VCS VERIFICATION REPORT

CECIC HKC GANSU CHANGMA WIND
POWER PROJECT

(VCS PROJECT ID:717)

Report ID	CTISC-NC-CBN-202303020-1
Project title	CECIC HKC Gansu Changma Wind Power project
Project ID	717
Verification period	01-Jan-2022 to 30-April-2023
Original date of issue	27-June-2024
Most recent date of issue	10-December-2024

Figure 2- Project boundary of the revised CDM PDD⁴

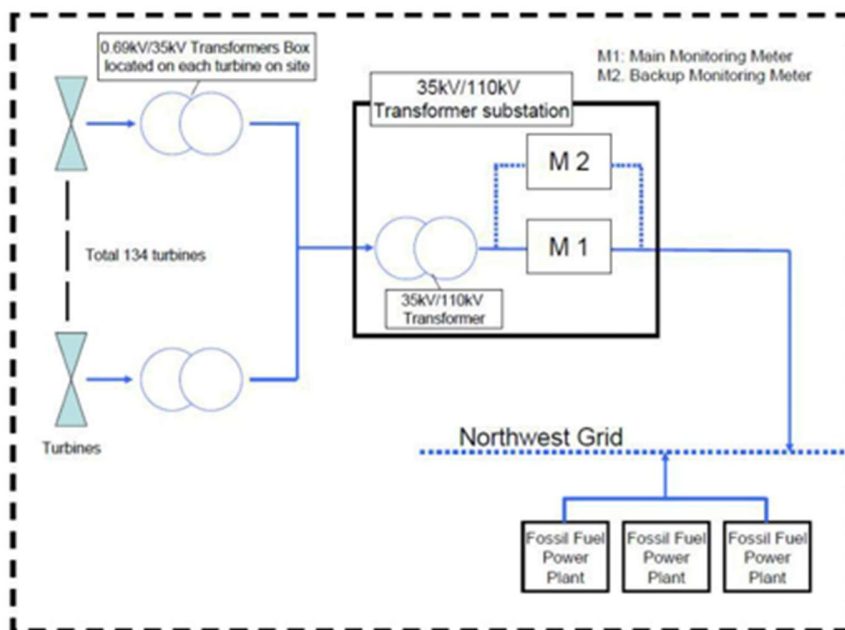
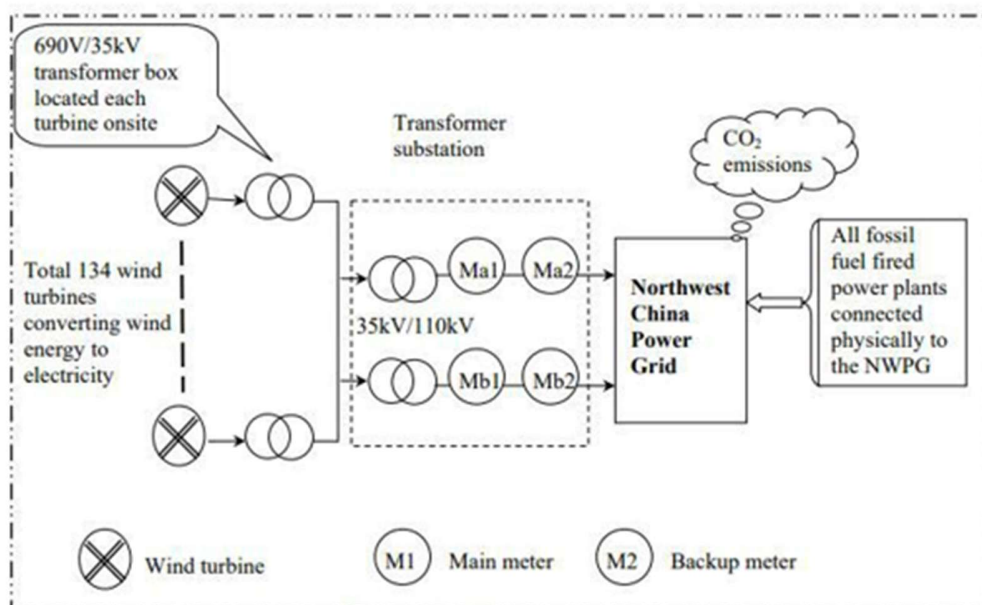
2. In the registered CDM PDD, the project boundary involves electricity meter M1 and M2 and the electricity was delivered to the grid via one 35kV/110kV transformer, while in the revised CDM PDD, the project boundary involves 4 electricity meters Ma1, Ma2, Mb1 and Mb2 and the electricity was delivered to the grid via two 35kV/110kV transformers. Please refer to figure 1 and 2 below for detail.

The verification team confirmed that this deviation will not lower the accuracy and conservativeness of the monitoring system and the project remains in compliance with VCS Program rules and this deviation
